# CITY OF ALBUQUERQUE

**Re: Sterling Downtown**  
**800 Silver Ave. SW**  
**Traffic Circulation Layout**  
Engineer's/Architect's Stamp XX-XX-XX (K13D013)

Based upon the information provided in your submittal received 4-3-17, the above referenced plan cannot be approved for Building Permit until the following comments are addressed:

**C1 SITE PLAN**  
 1" = 20'-0"

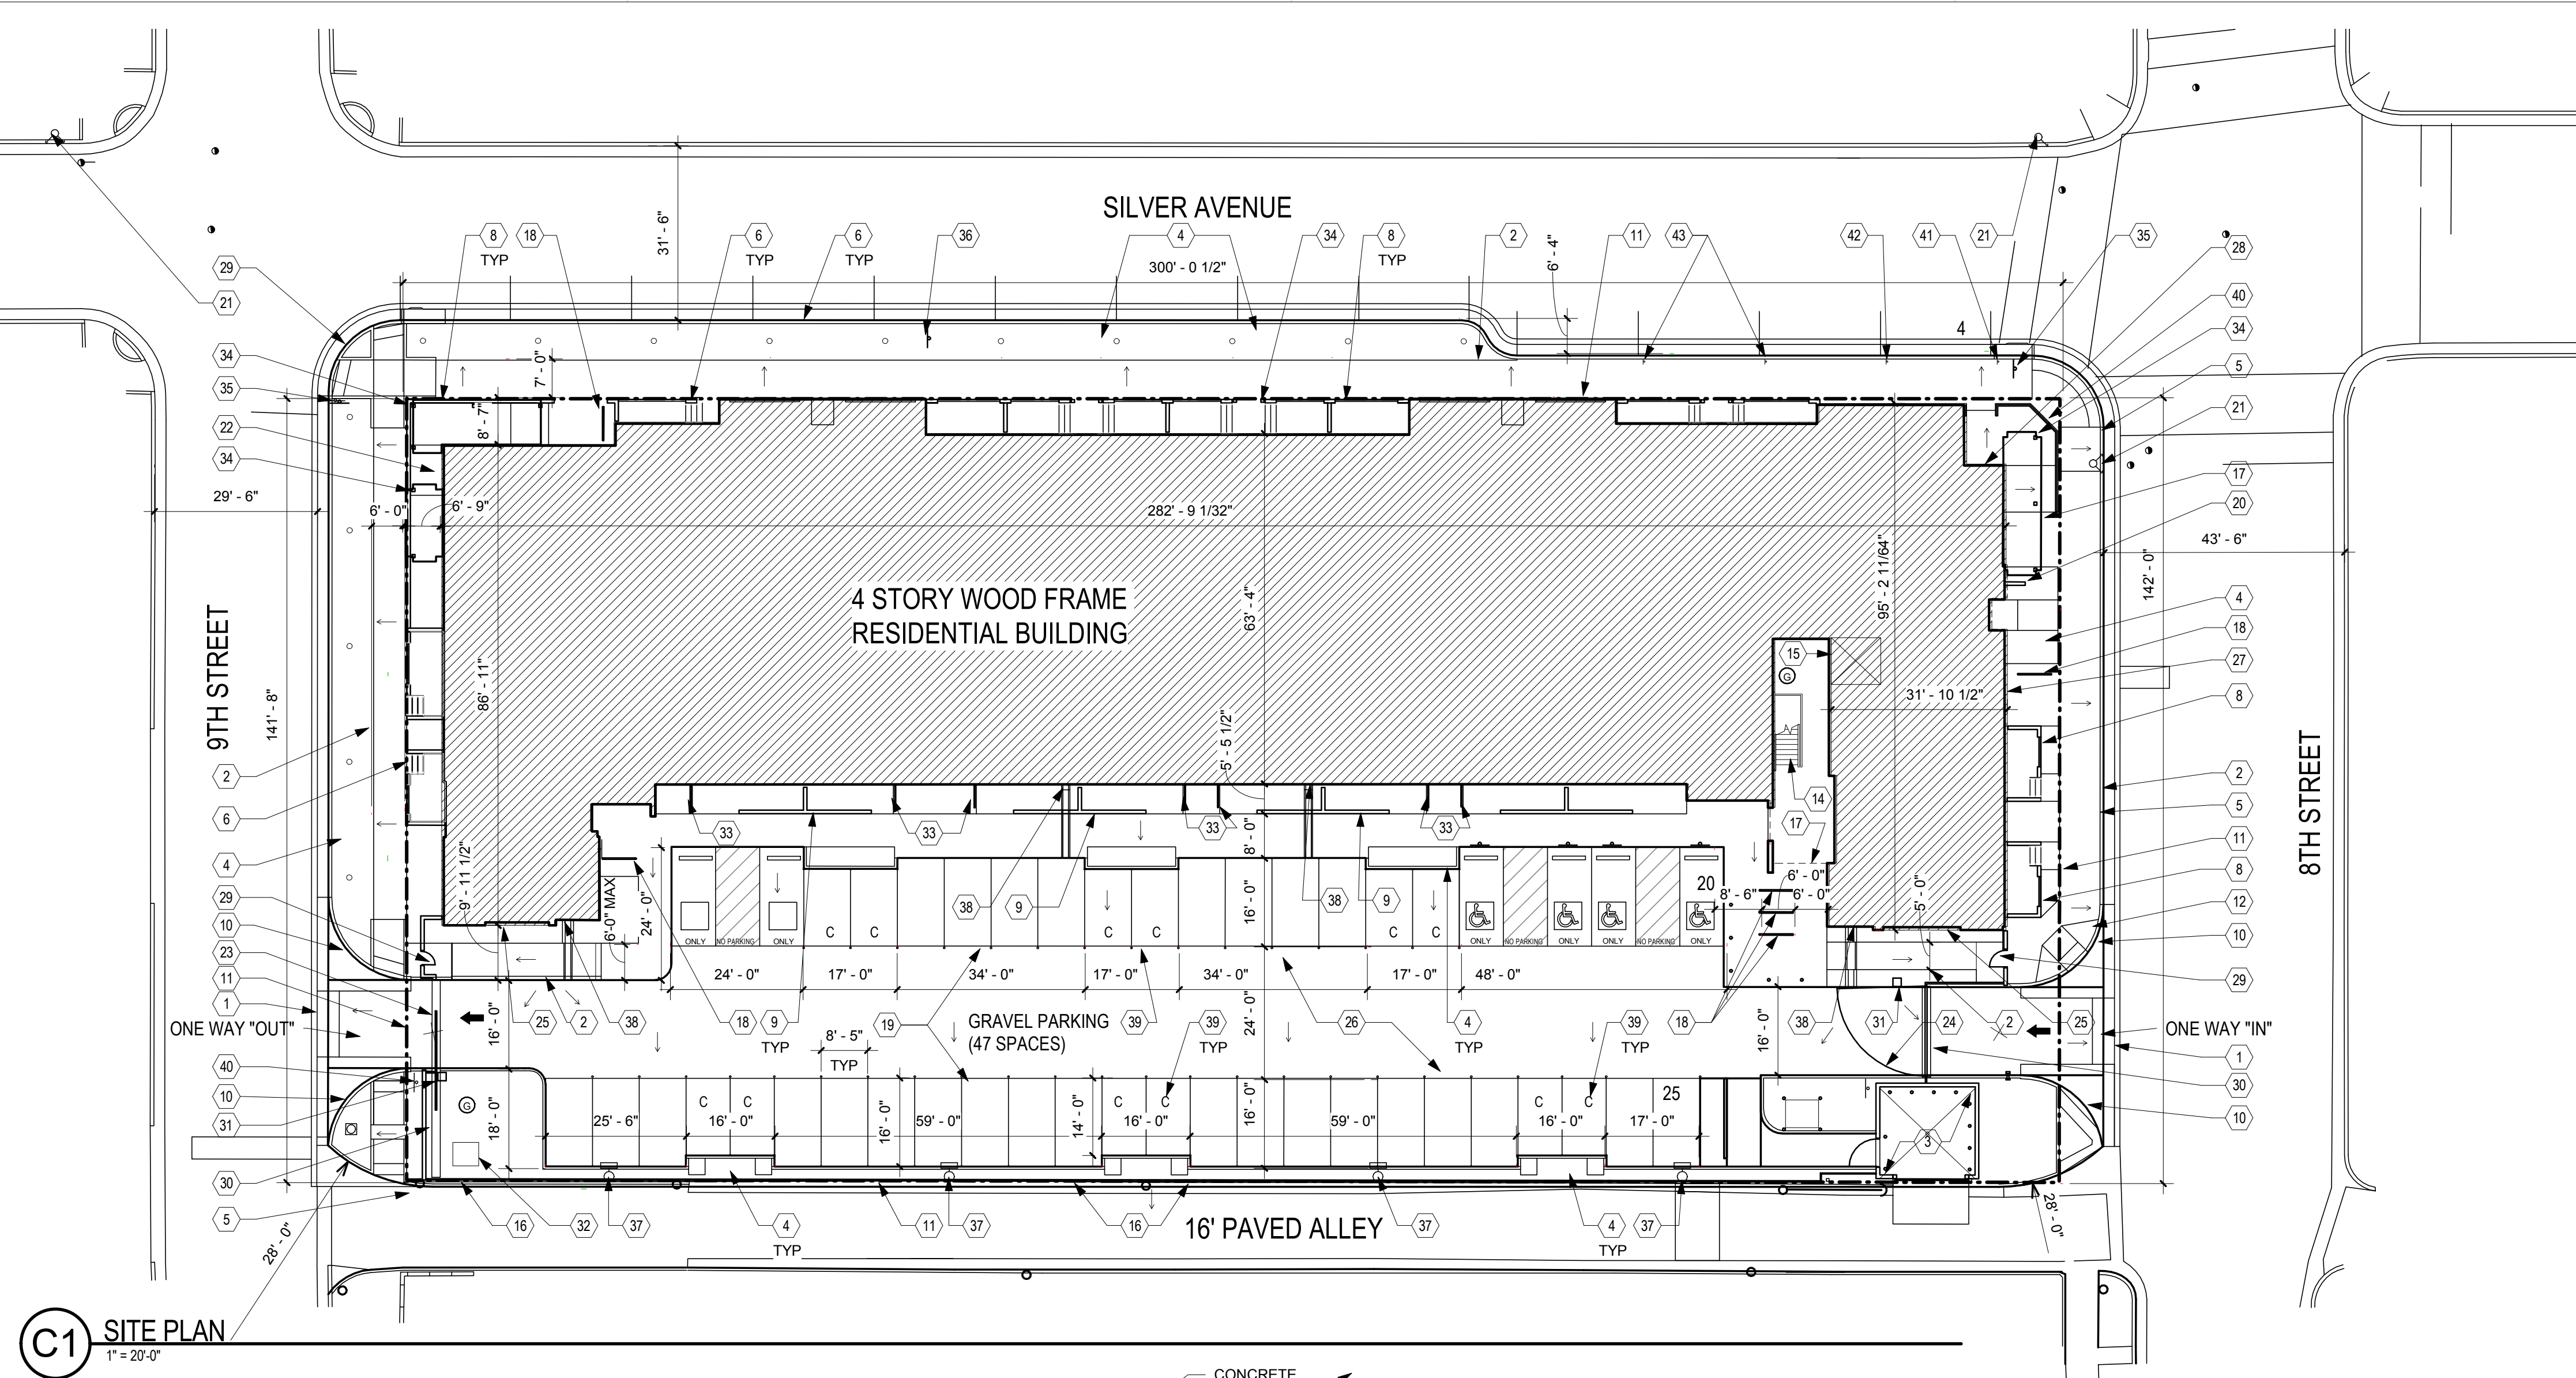
1. The traffic circulation layout must be stamped, signed, and dated by an engineer or architect licensed in the state of New Mexico.
2. Label the compact parking spaces by placing the words "**COMPACT**" on the pavement of each space. The compact parking spaces need to be identified to the drivers.

4. The ADA parking space has a clearly visible, blue, International Symbol of Accessibility painted on the pavement at rear of the space (66-1-4. 1.E NMSA 1978) or MUTCD recommended a white symbol on a blue background. There are more accessible parking spaces than what is shown in the parking calculations. The accessible spaces on the west side are not showing the symbols.

5. Please dimension all sidewalk width. Some dimensions are not shown.
6. Provide a min 6" or max 8" high concrete barrier curb or other acceptable barrier between landscaping and parking areas and/or drive aisles. Please call out detail and location of barrier curb.

7. One-way vehicular paths require pavement directional signage and a posted "**Do Not Enter**" sign at the point of egress. Please show detail and location of posted signs.

8. Unused curb cuts must be replaced with sidewalk and curb & gutter. A build note must be provided referring to the appropriate City Standard drawing.

9. Add a note stating "All broken or cracked sidewalk must be replaced with sidewalk and curb & gutter." A build note must be provided referring to the appropriate City Standard drawing.
10. All accessible concrete ramp need to be updated to current ADA standard.
11. Please provide a detail for the gravel section.
12. The TCL should reflect the finished site. Provide notes showing what work is included on the work order and the private work on site.
13. Work within the public right of way requires a work order with DRC approved plans.
14. Please provide detail for the edge treatment for the gravel section.
15. Will on-street parking be removed with work order?

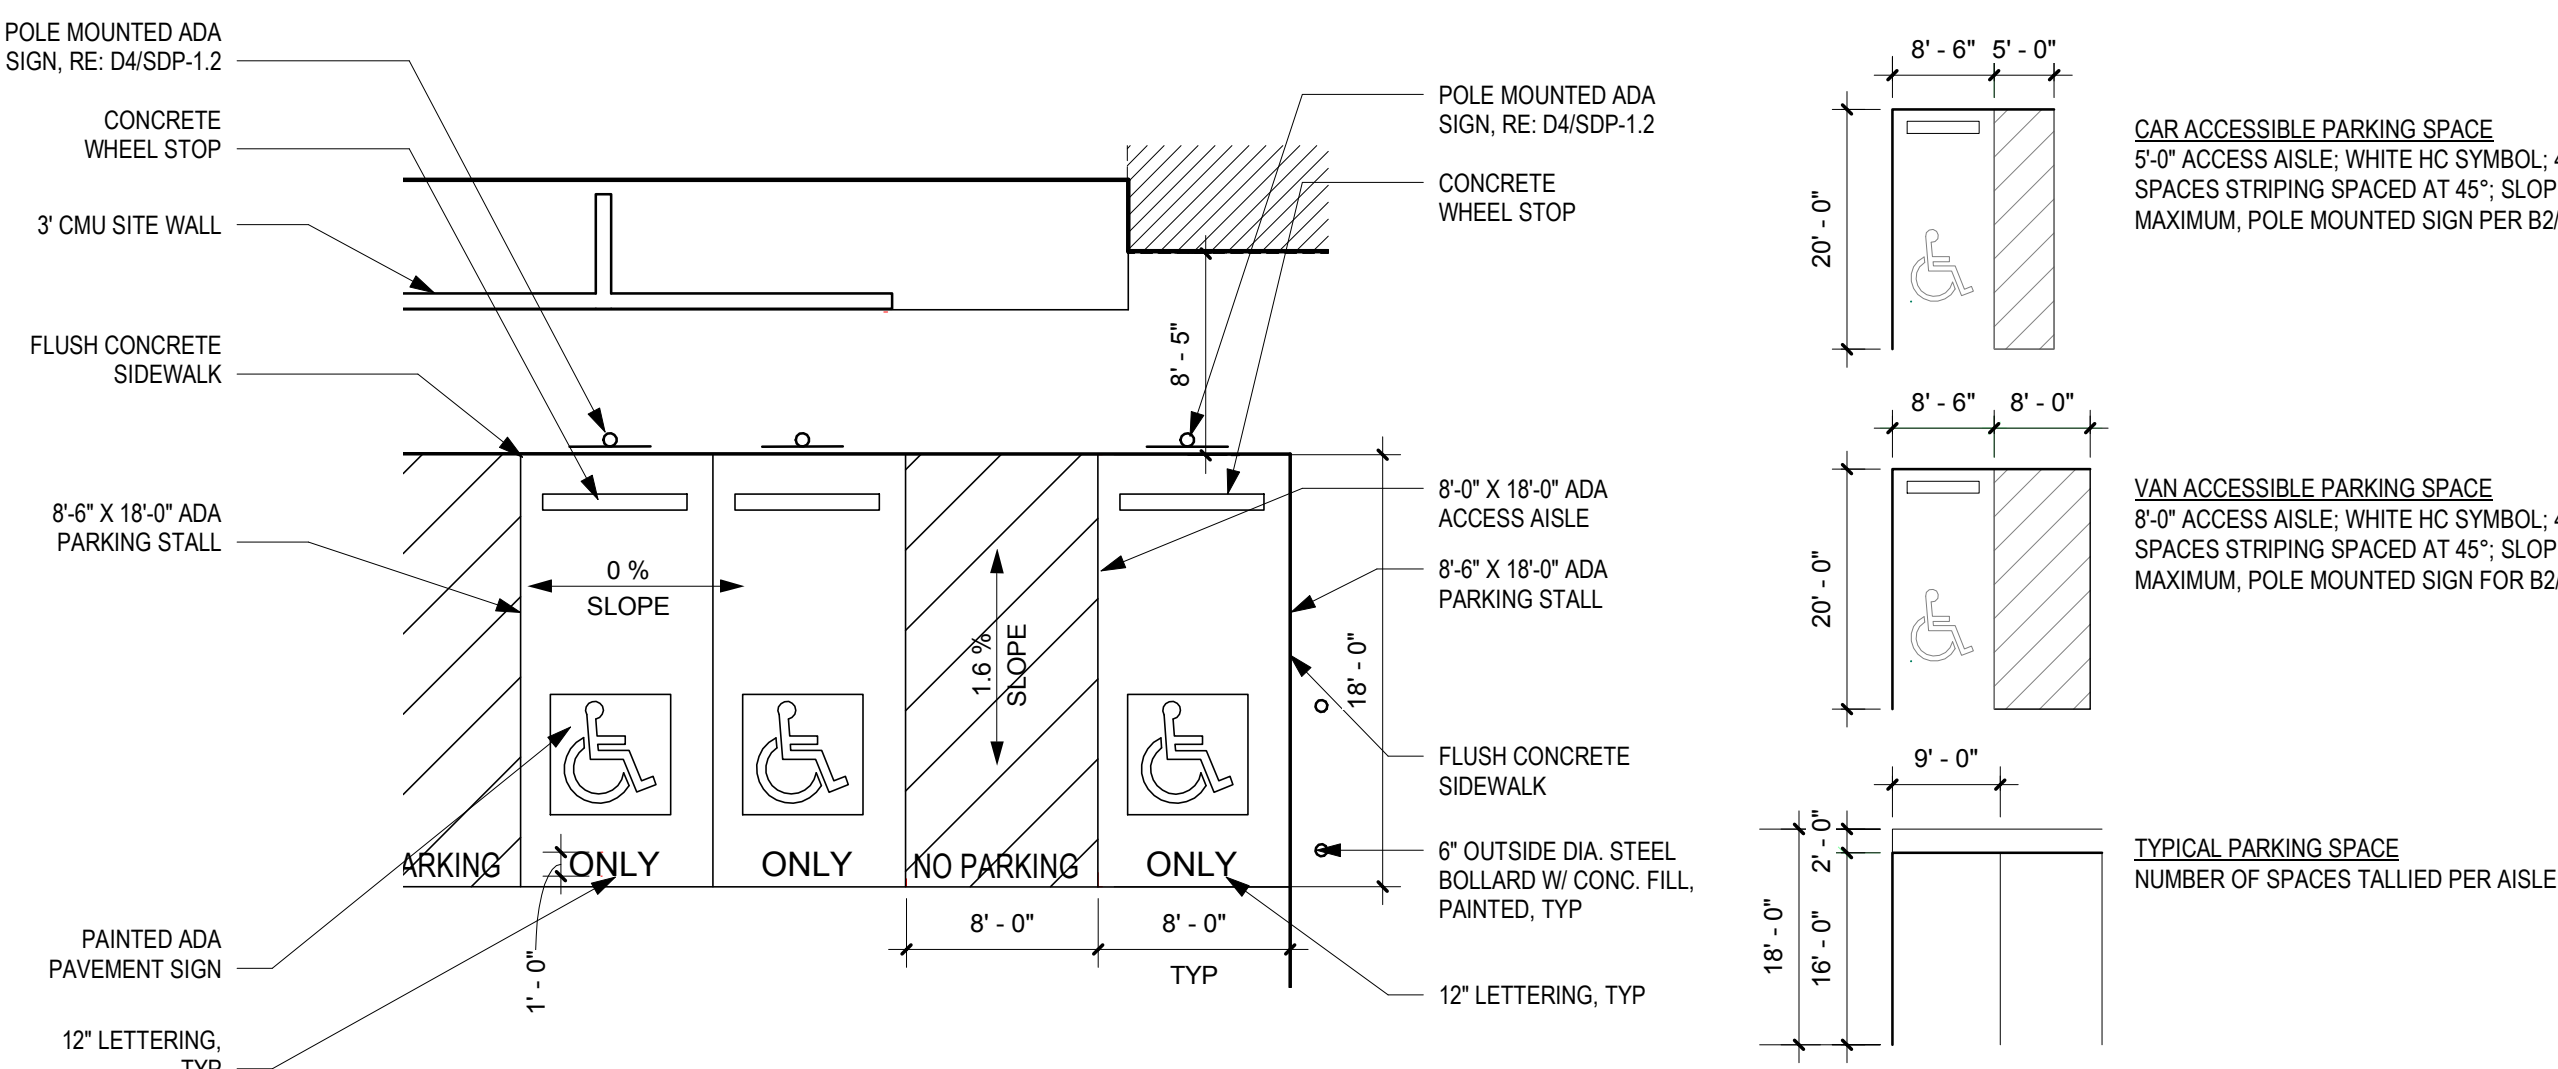
3. The ADA accessible parking sign must have the required language per 66-7-352.4C NMSA 1978 "**Violators Are Subject to a Fine and/or Towing.**" Please call out detail and location of HC signs.
